Galway City Cycle Network

Doughiska Road South

Report to Council

May 2022

Figure 2 - Additional bollards proposed, and extension of cycle lane

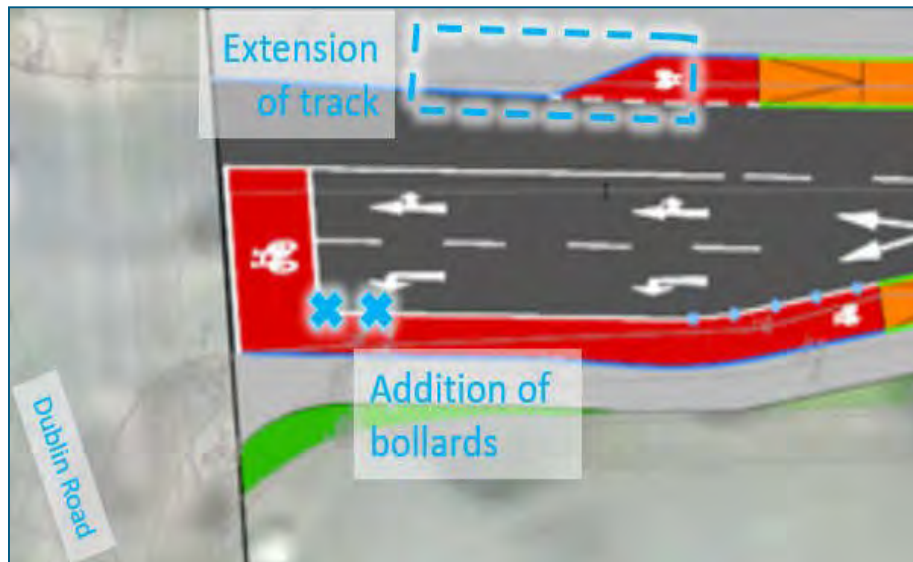
- The installation of additional bollards locally at the northern end of the scheme, to protect cyclists from vehicles turning left onto Dublin Road, as shown in Figure 2.
- The extension of the southbound cycle lane closer to the Dublin Road junction, as shown in Figure 2.
